ZONING BOARD OF APPEALS STAFF REPORT

REGARDING: 48700 Grand River Ave, Parcels # 50-22-17-126-009 (PZ19-0013)

PLAN REVIEW CENTER REPORT

Interior Environments Parking Expansion
JSP 18-51

SITE PLAN

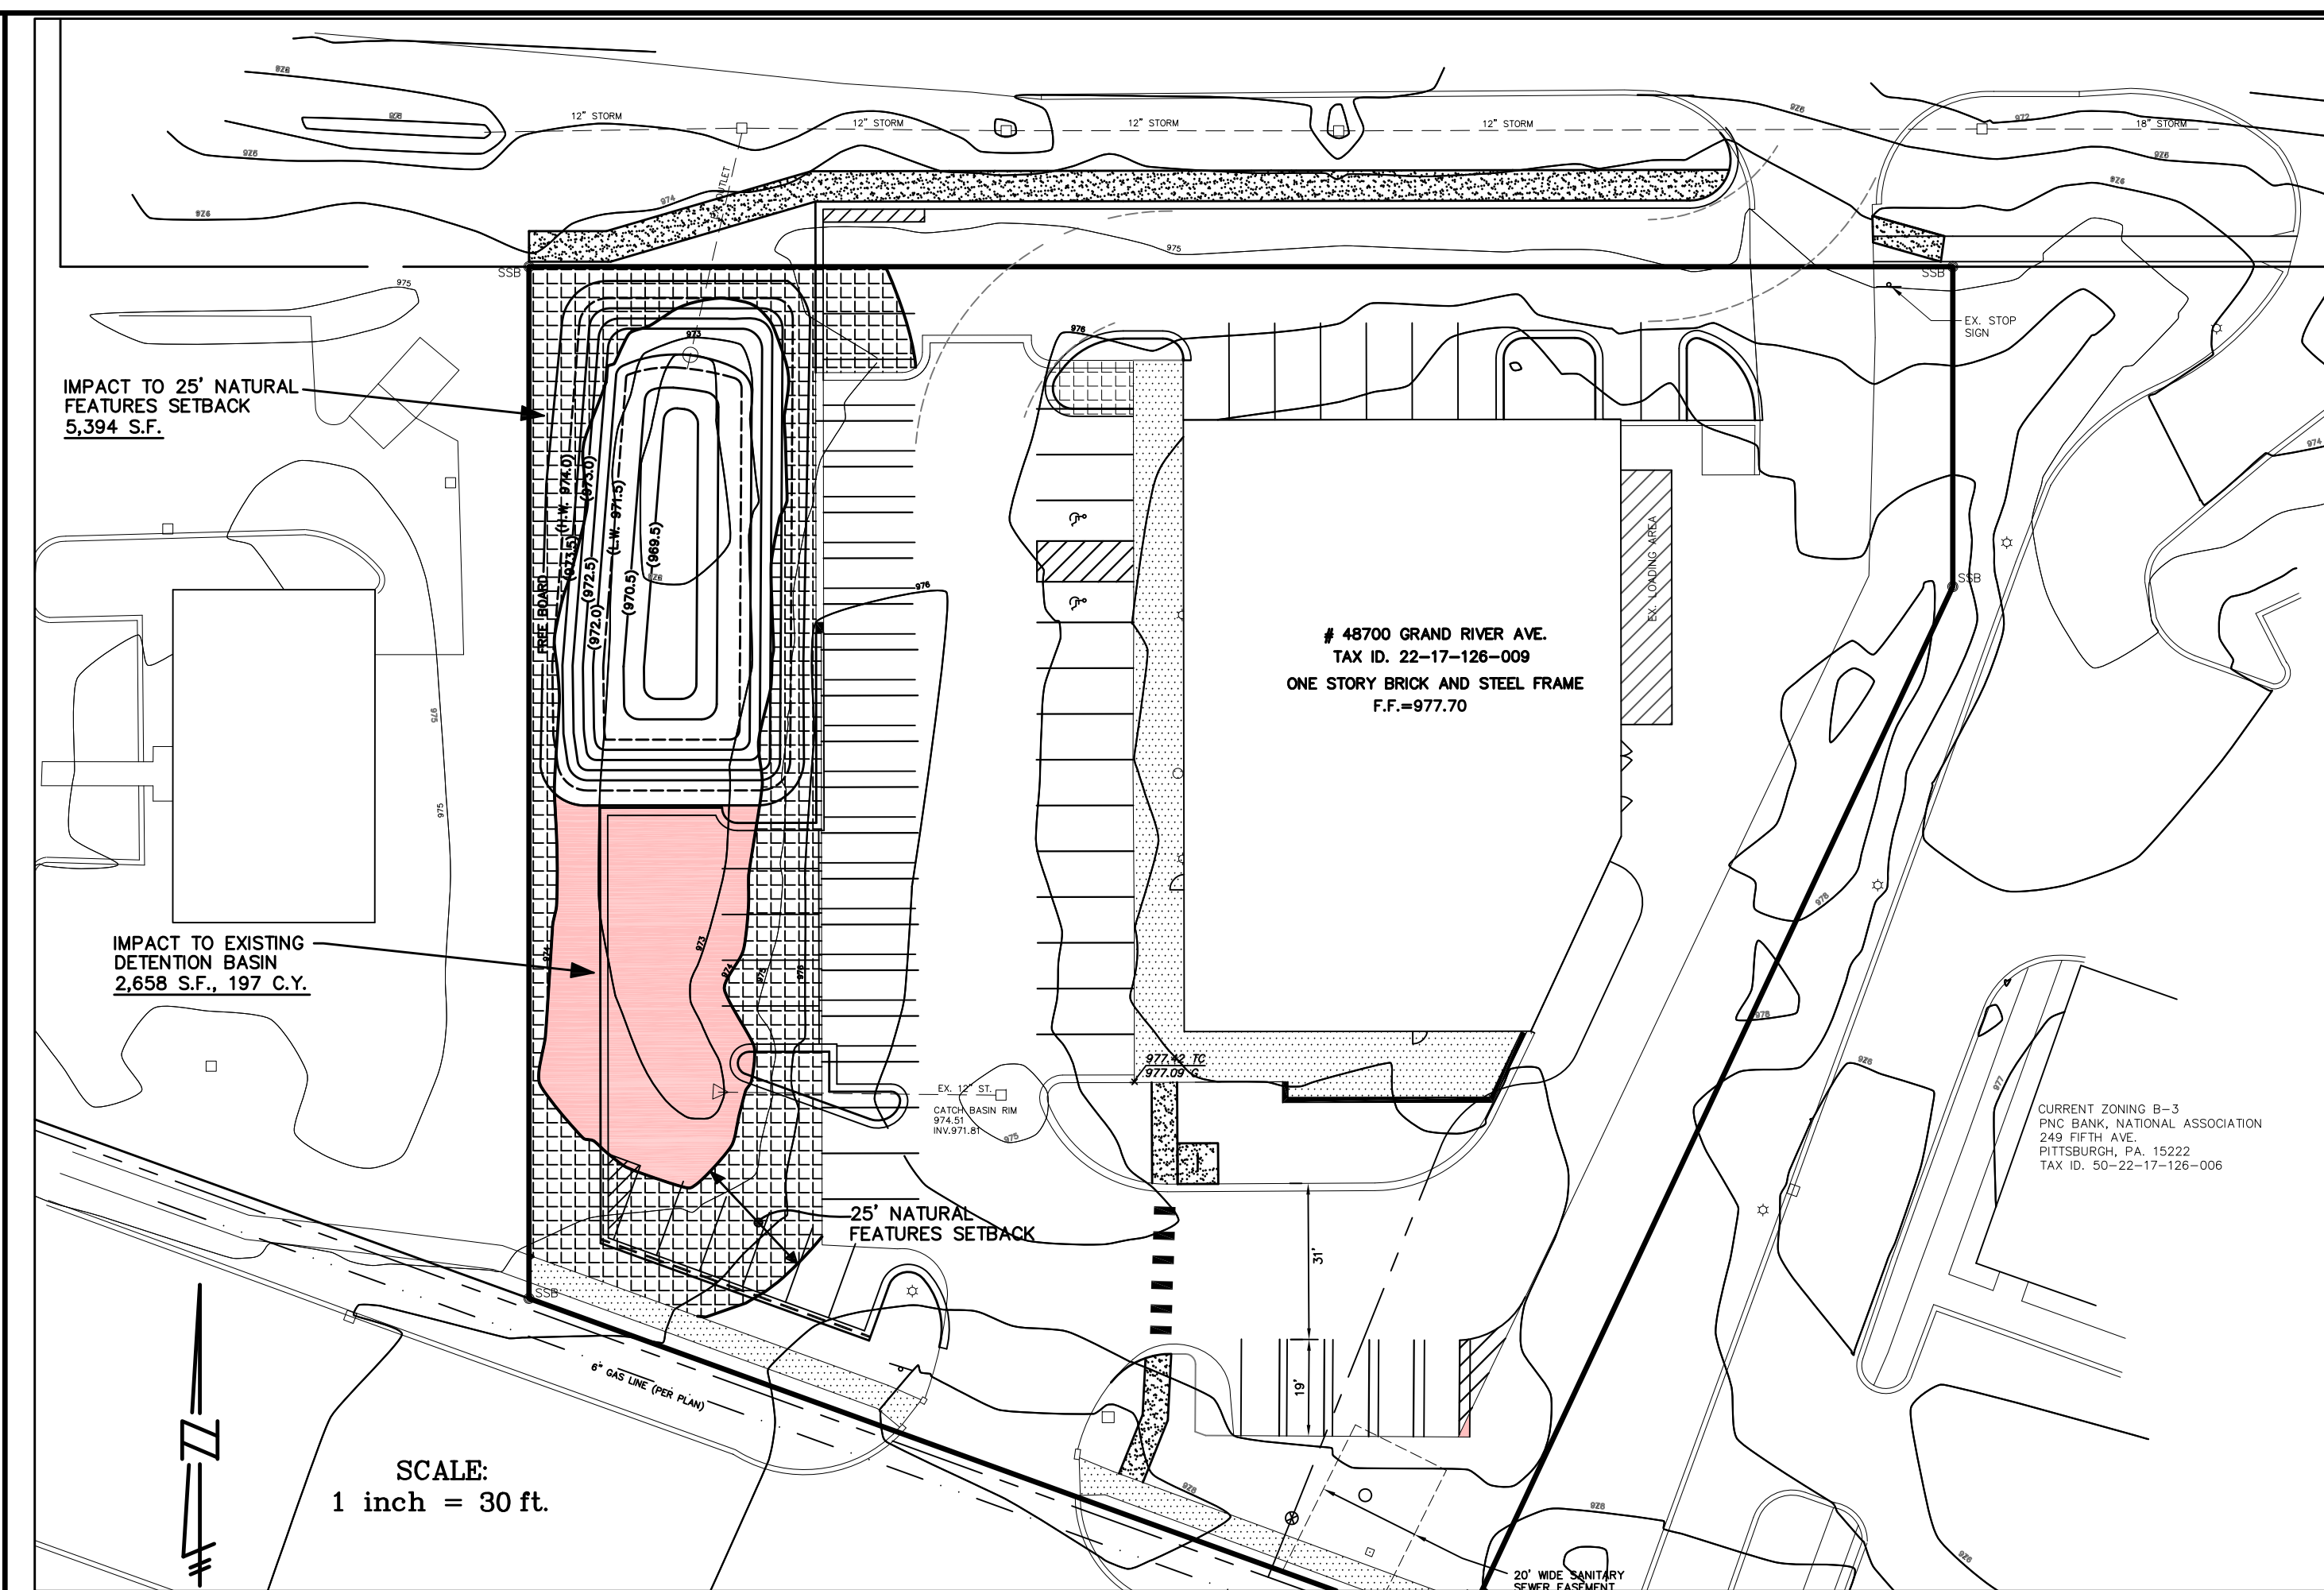
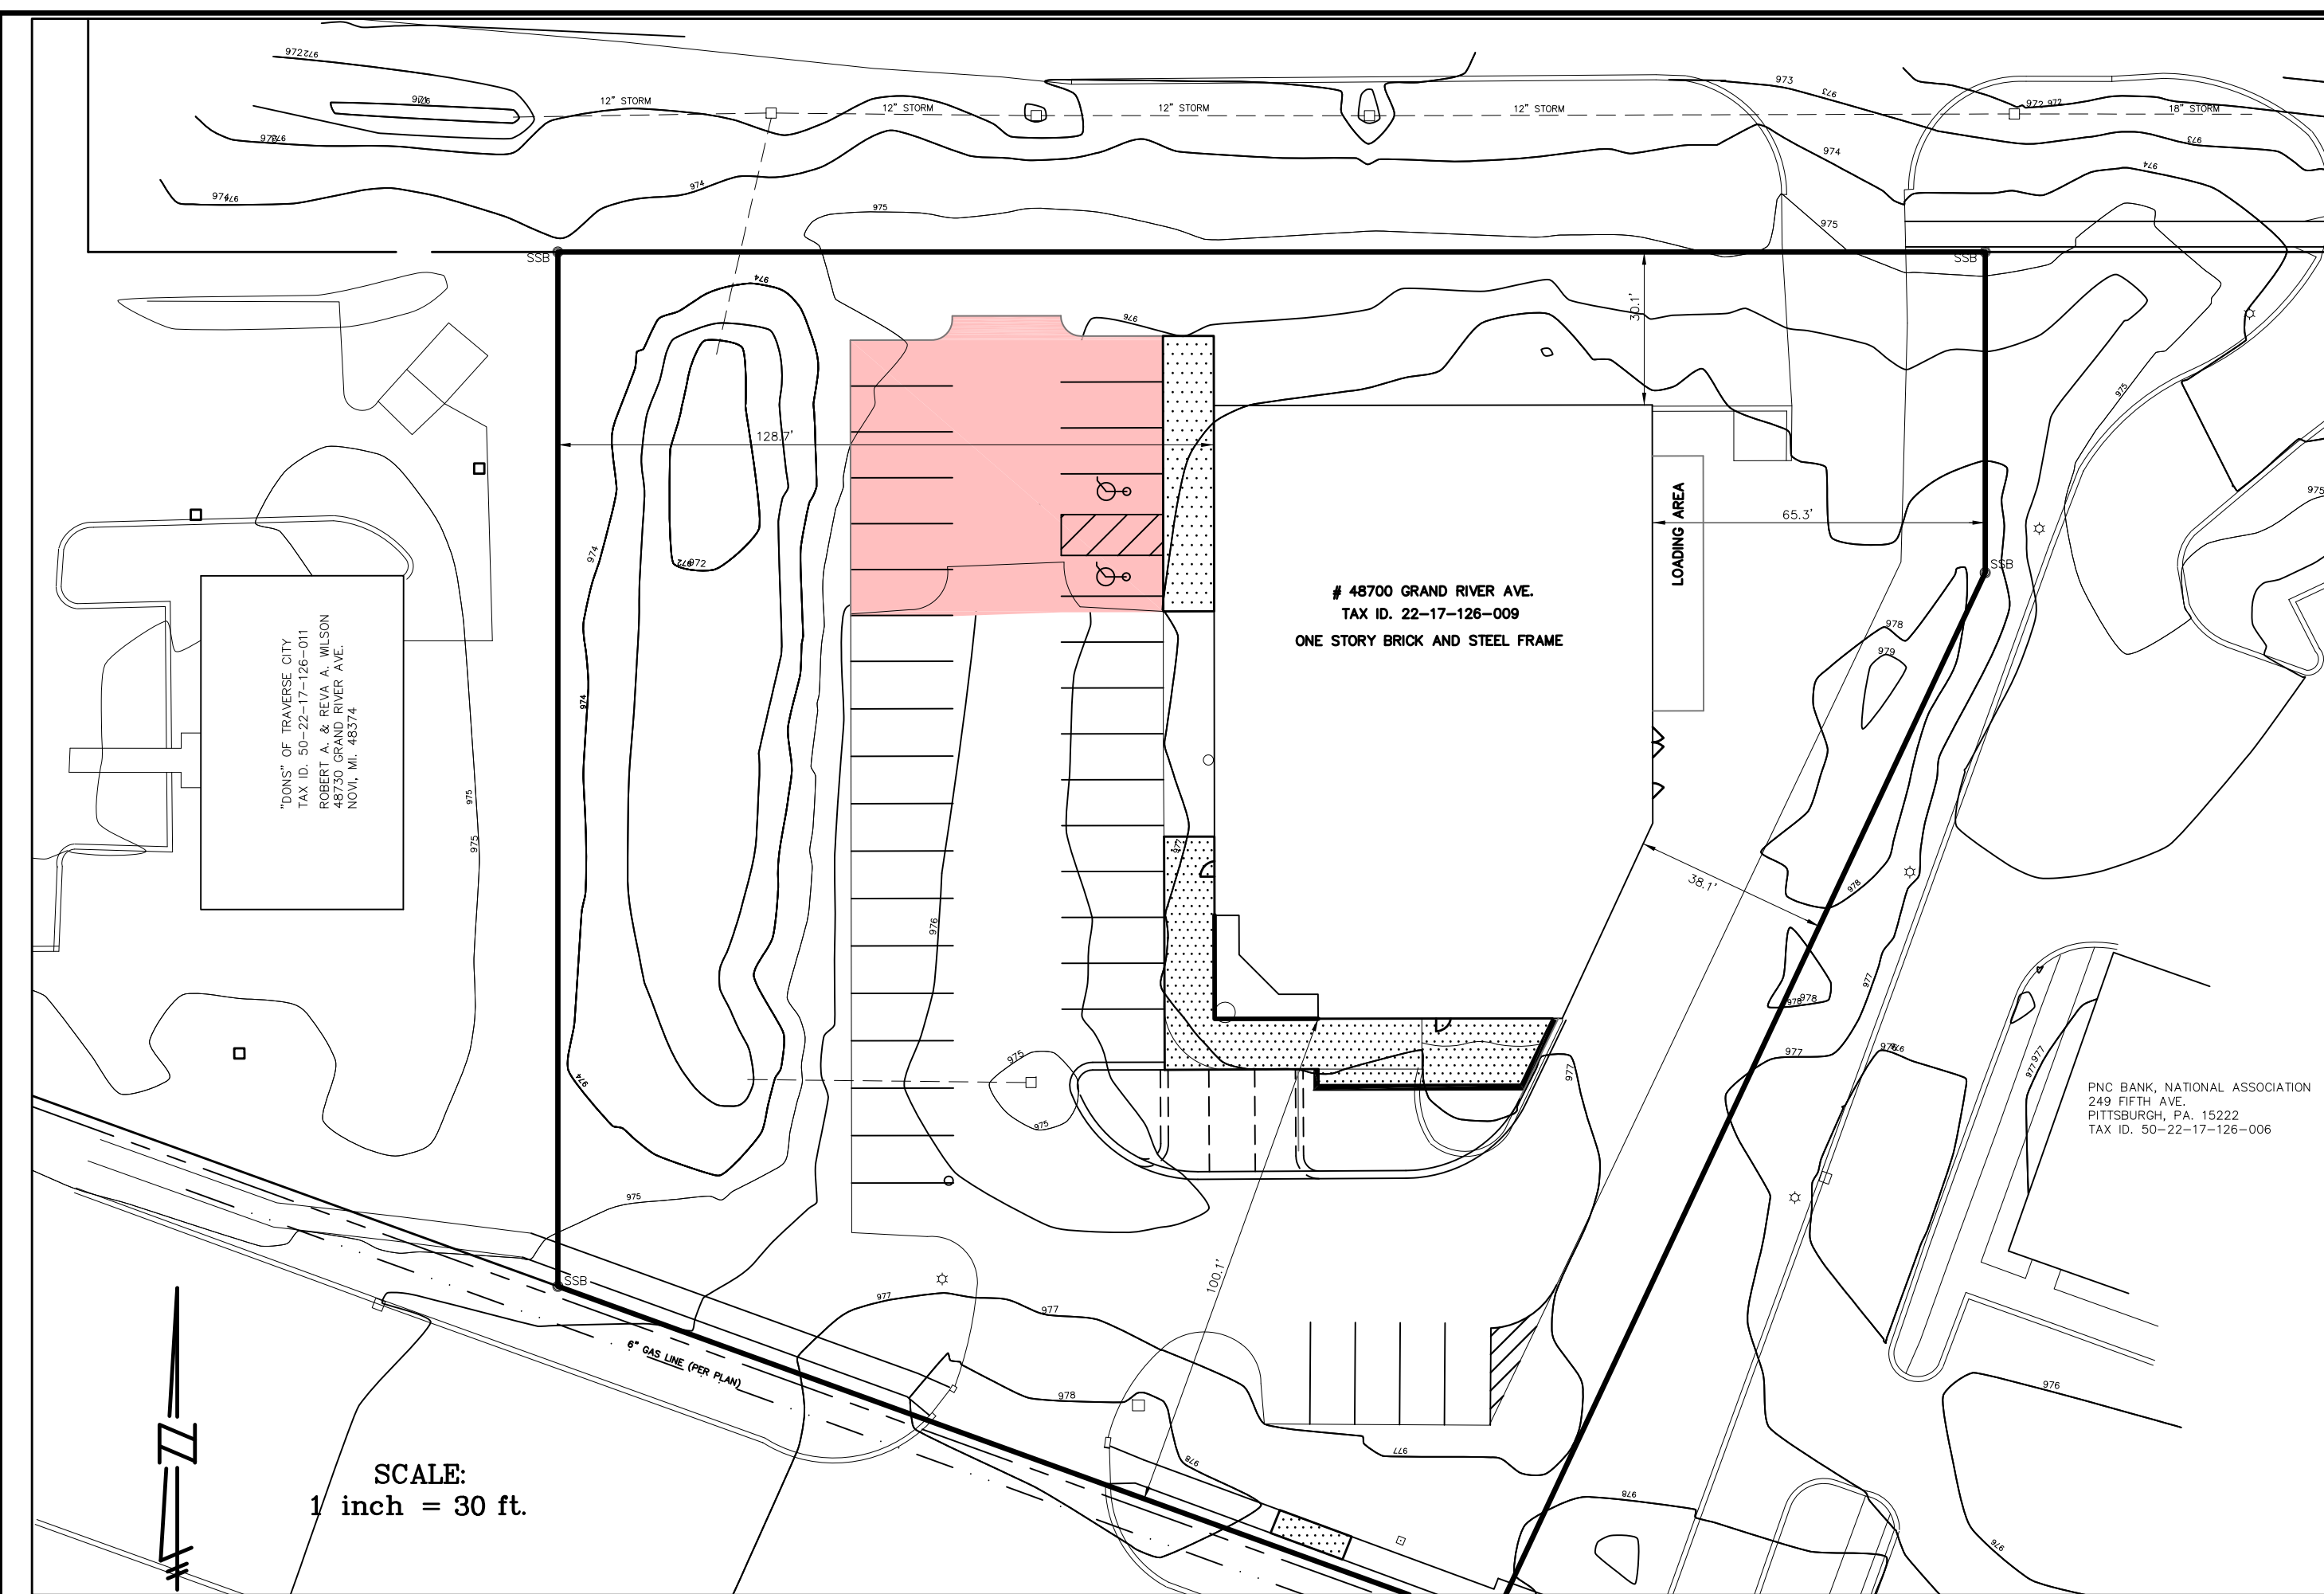
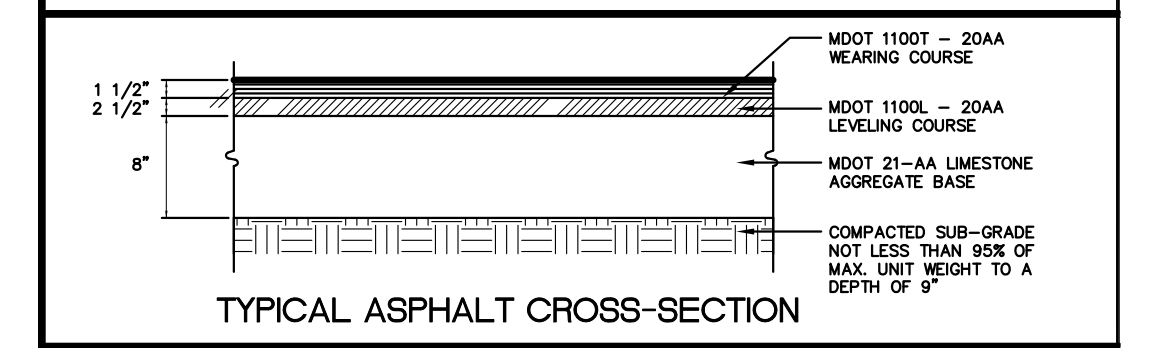
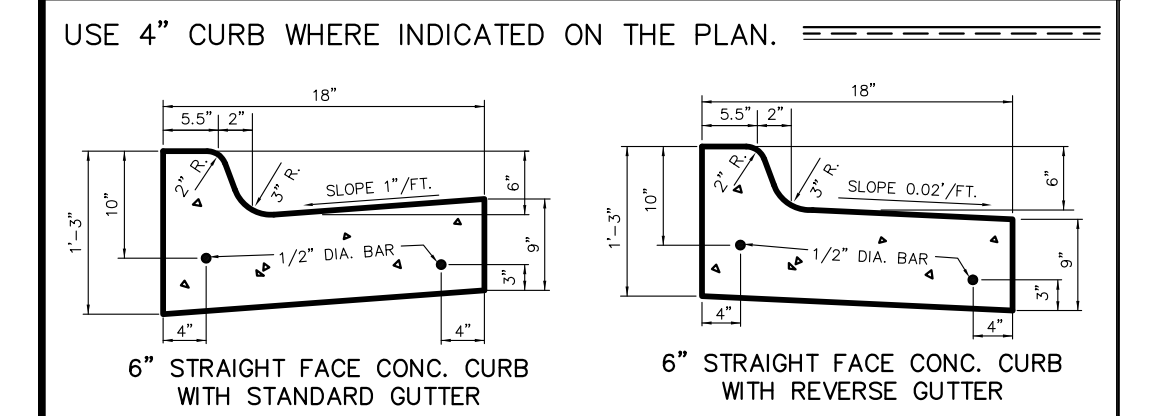
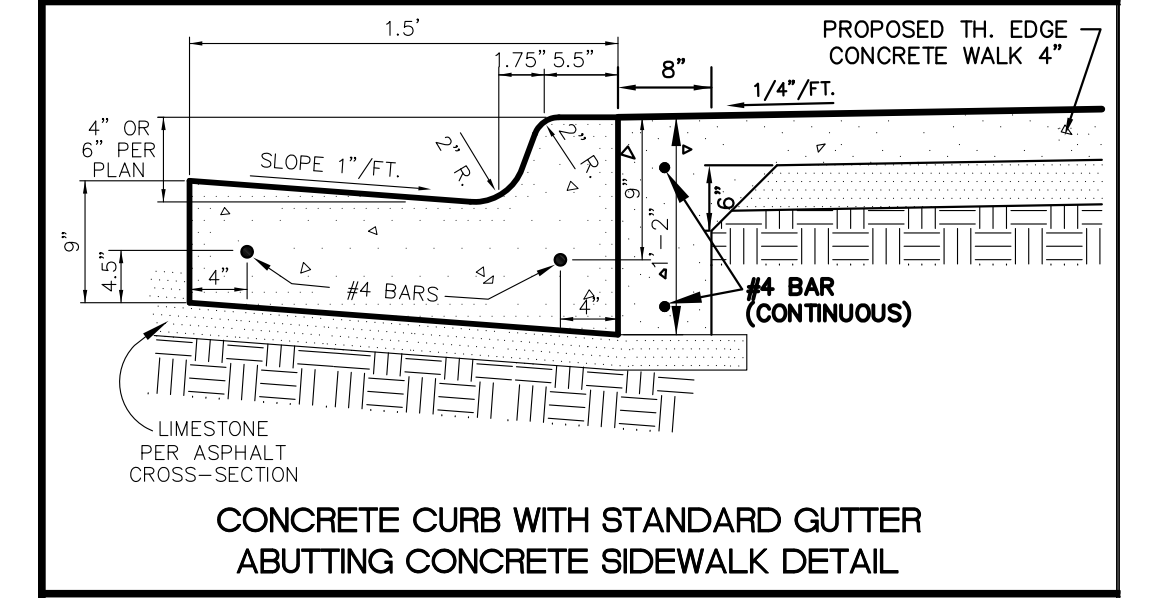
1. Parking Setbacks (Sec 3.1.23.D): The expansion to the parking lot would encroach 15 feet into the right-of-way (ROW) for Twelve Mile Road on the north side of the property, resulting in zero setback from the property line, and one parking space in the ROW. The applicant has provided an email from the Road Commission of Oakland County (RCOC) indicating the 15-foot encroachment into the ROW is acceptable. Parking is also proposed within the required parking setback on the south side adjacent to Grand River Avenue. **The required parking setback of both frontages is 20 feet, so the applicant must request variances from the Zoning Board of Appeals. Staff recommends the applicant remove the one parking space that falls within the right-of-way.**

2. End Islands (Sec. 5.3.12): Parking islands abutting traffic circulation aisles are generally required to be 3 feet shorter than the adjacent parking space. The applicant has indicated one end island on the western side of the south entrance needs to be 18 feet long to accommodate an existing light pole. **The applicant should request a variance from the Zoning Board of Appeals for this deviation.**

(1) NOW VARIANCE REQUIRED FOR LESS THAN 20' PARKING SETBACK
 RCOC APPROVAL REQUIRED FOR PAVING IN 12 MILE ROAD R.O.W.

(2) NOW VARIANCE REQUIRED FOR LESS THAN 20' PARKING SETBACK

(3) NOW VARIANCE REQUIRED FOR MORE THAN 16' FOR END ISLAND DEPTH

- PROPOSED VARIANCE**
- ZONING VARIANCE FOR PARKING SETBACK ALONG 12 MILE ROAD:
 REQUIRED= 20'
 PROPOSED= 0'
 - ZONING VARIANCE FOR PARKING SETBACK ALONG GRAND RIVER AVE.:
 REQUIRED= 20'
 PROPOSED= 14.5'
 - ZONING VARIANCE FOR END ISLAND DEPTH AS NOTED ON THE PLAN:
 REQUIRED= 16'
 PROPOSED= 17.5'
